Proposal Request

PROJECT: *(name and address)*
AWSOM
Bentonville, Arkansas

PROPOSAL REQUEST 043

Updates to Doors and Frames from Submittal Notes

Contents:
INTERIOR GLAZING SYSTEM ELEVATIONS - STOREFRONT - L2, L3

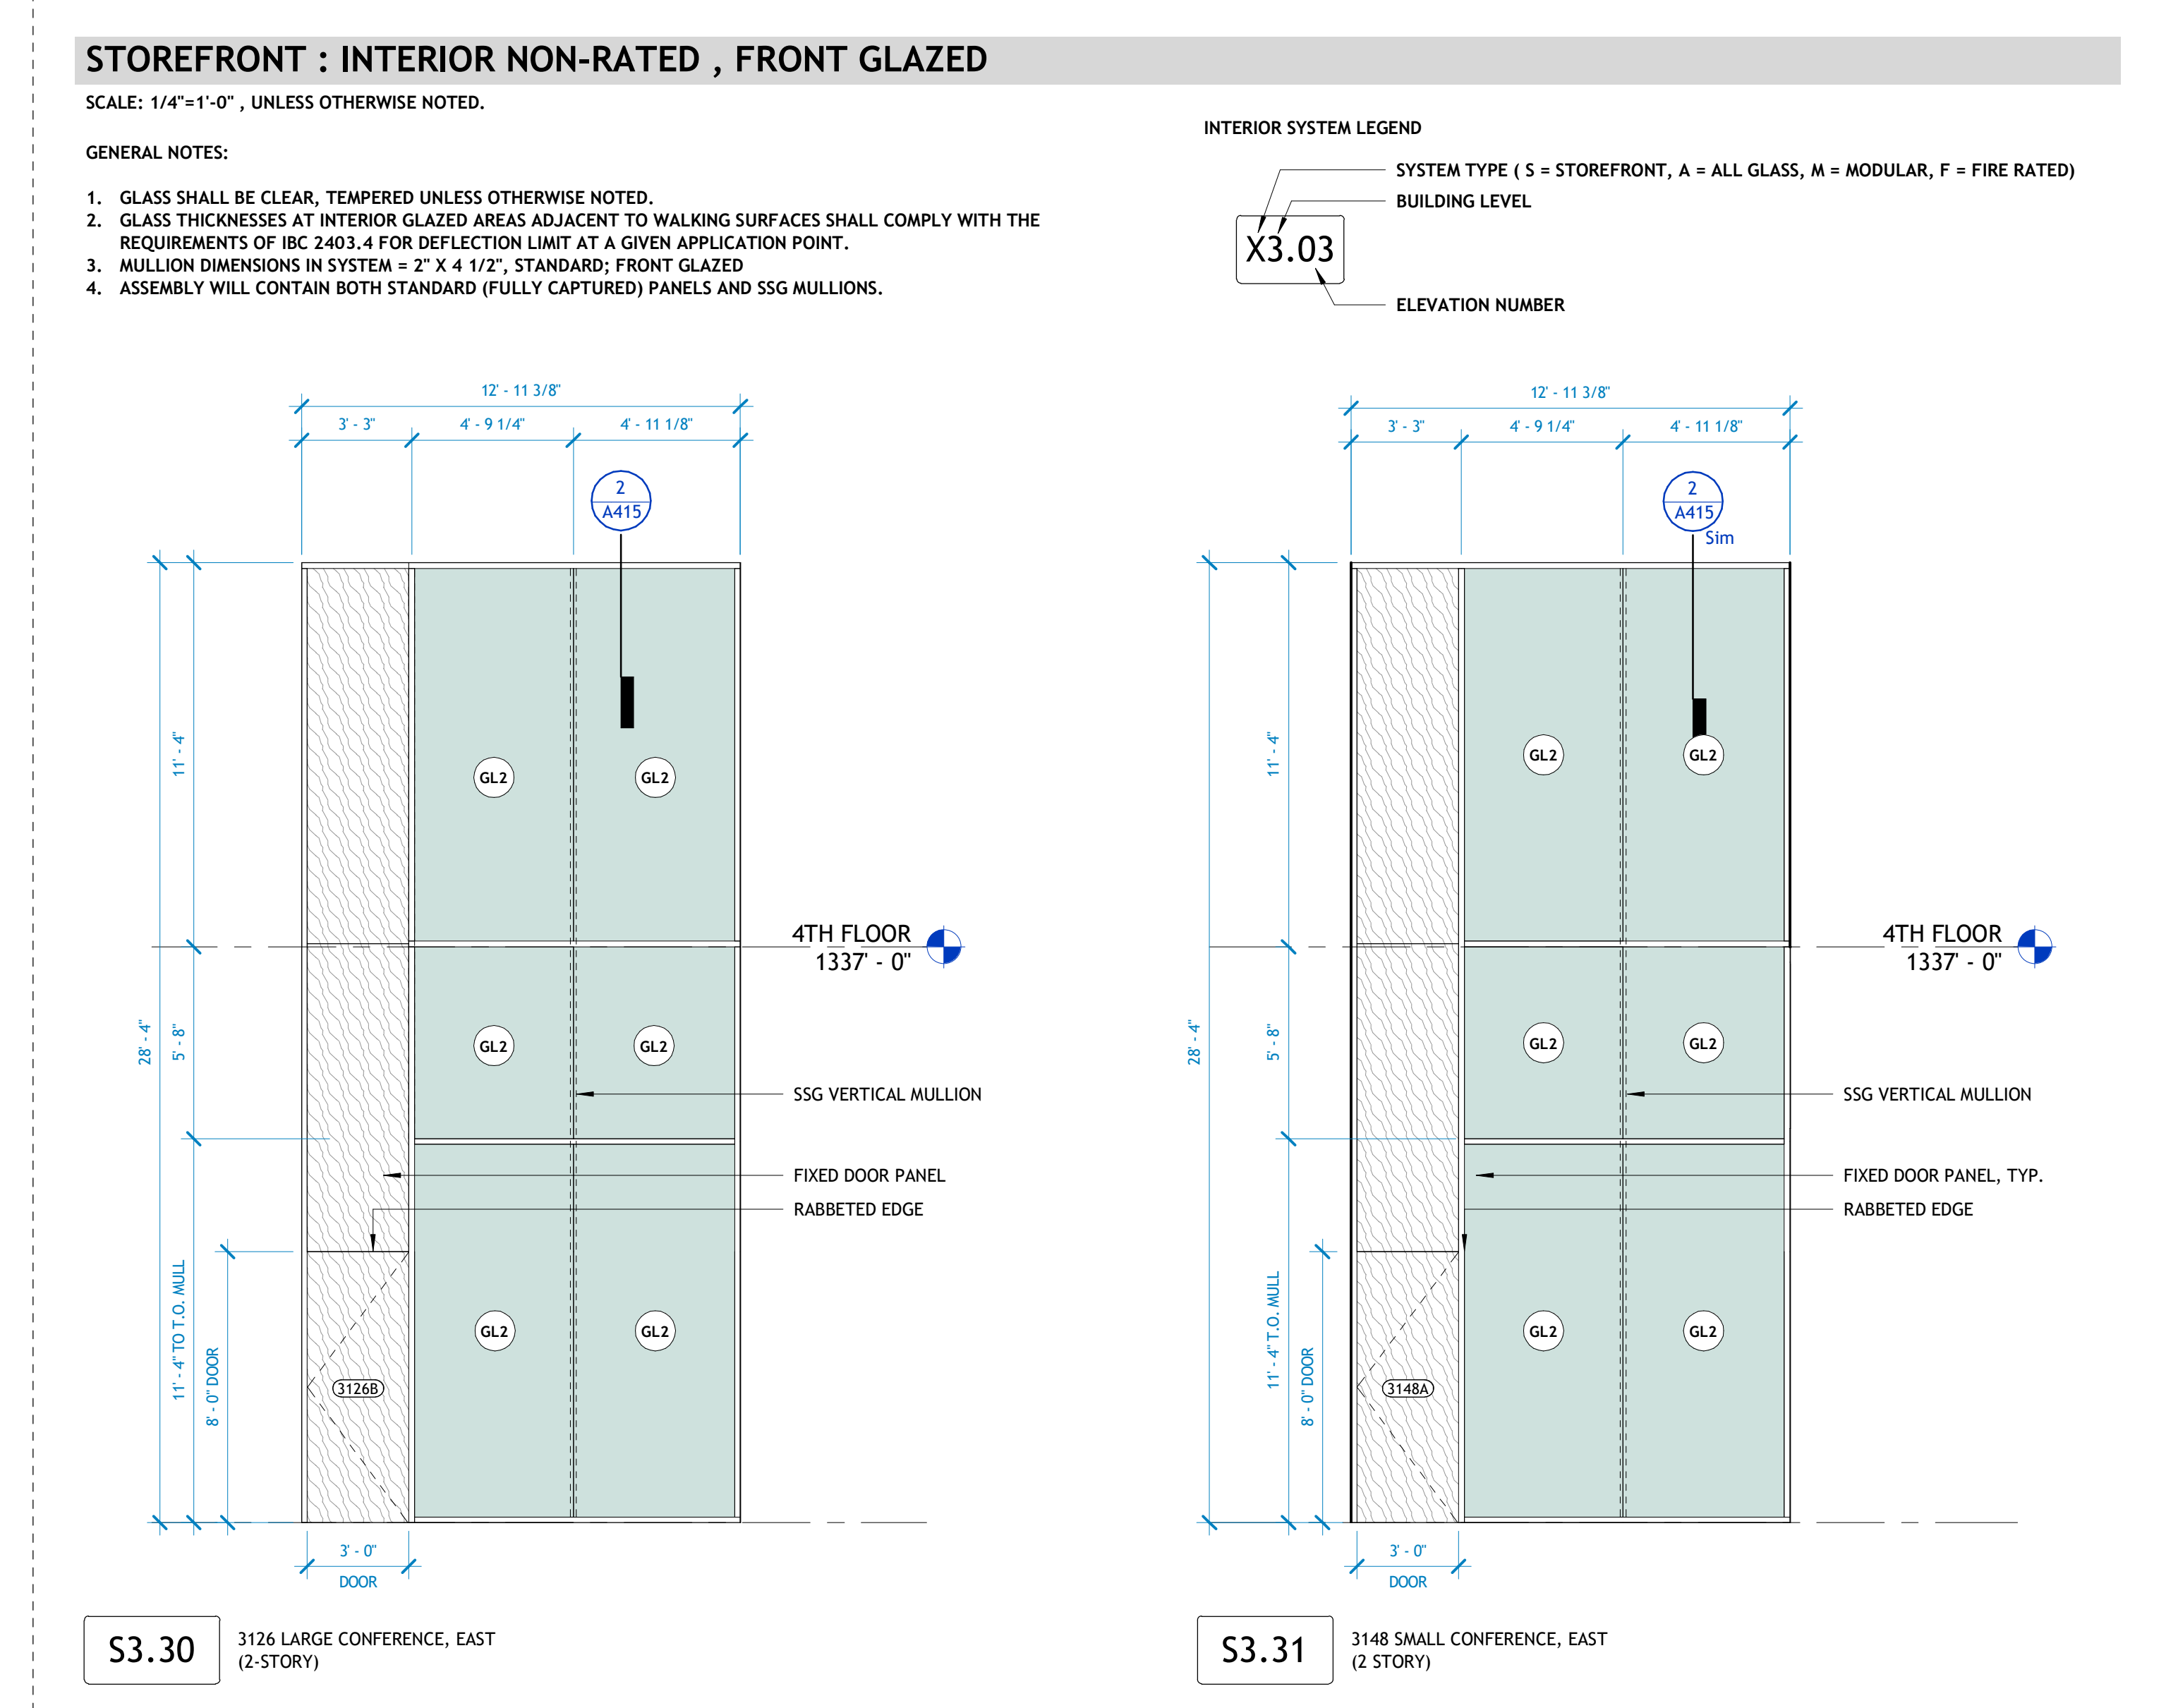
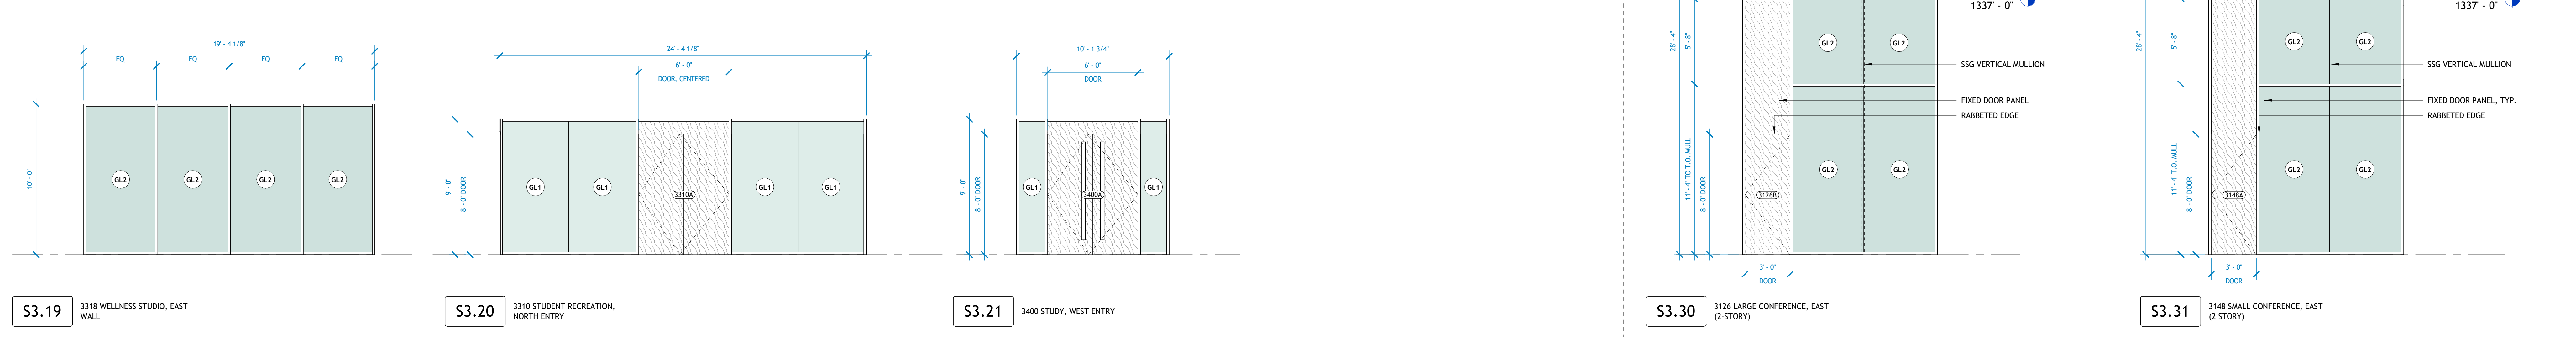
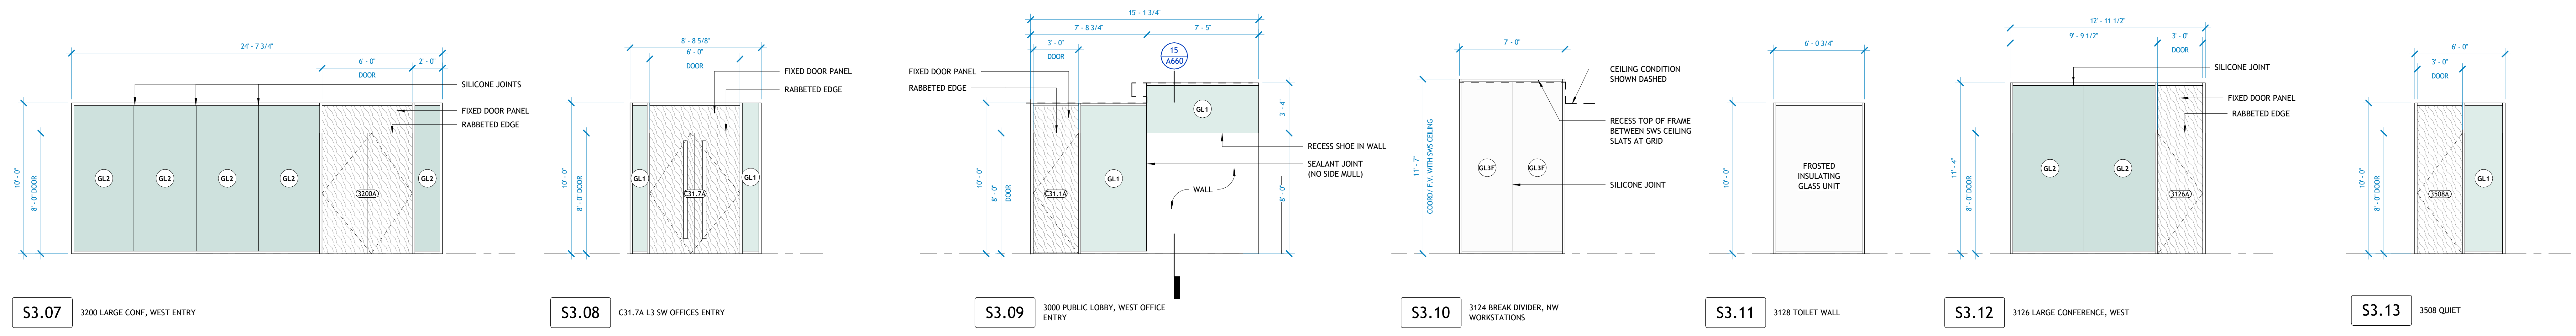
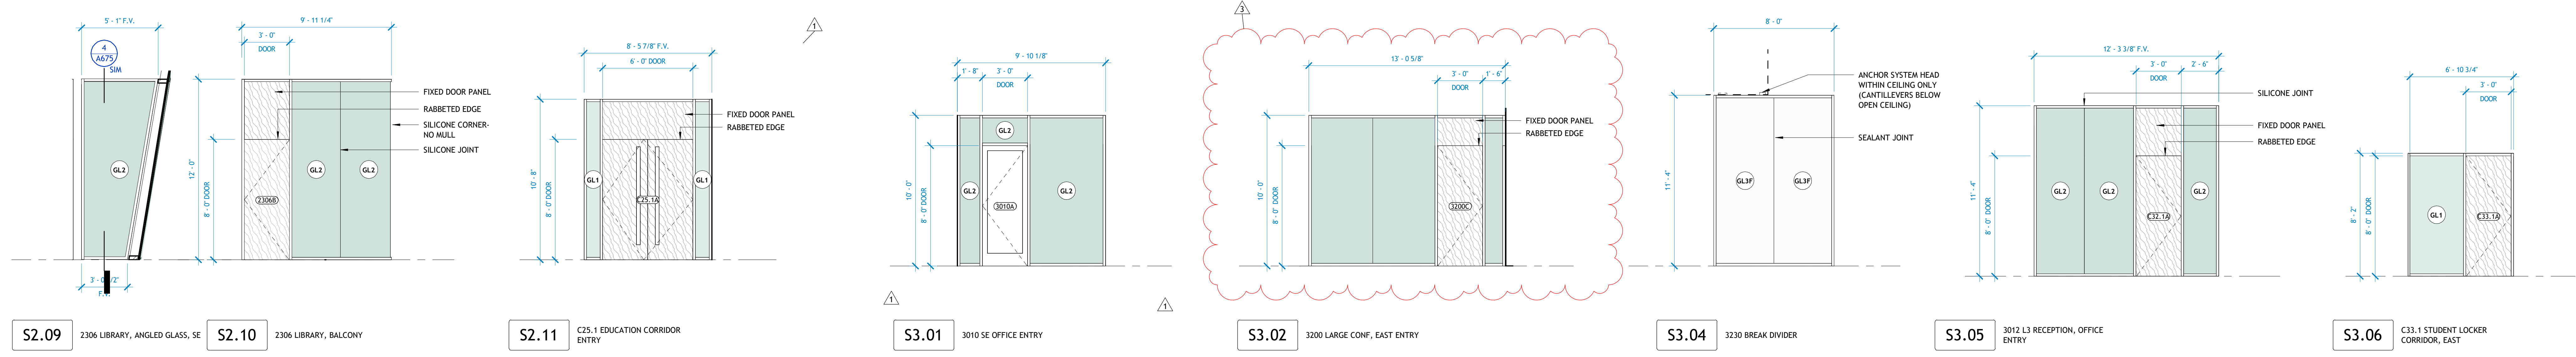
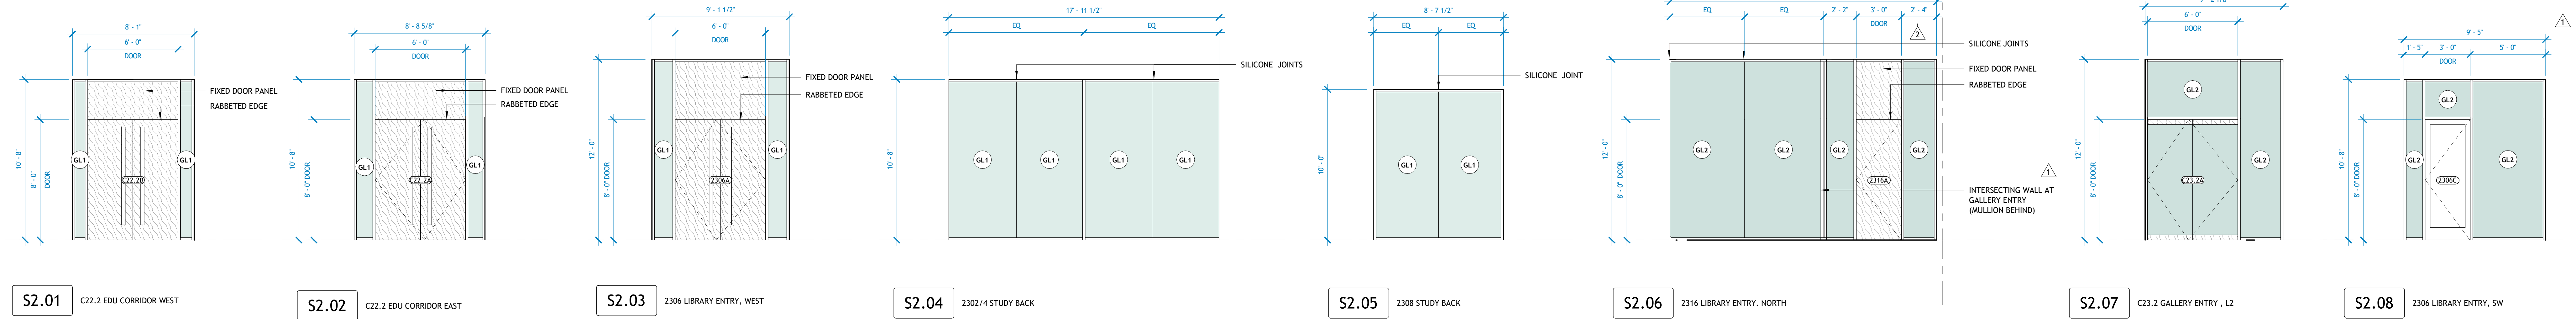
- g) Refer to Revised Sheet **A751 Interior Glazing System Elevations – Storefront L2, L3** with original issue date 02.24.2023 and revision date 04.02.2024.

- Added Elevation S3.02, at L3 Conference Room, East Entry (Shown on plan, but not previously elevated).
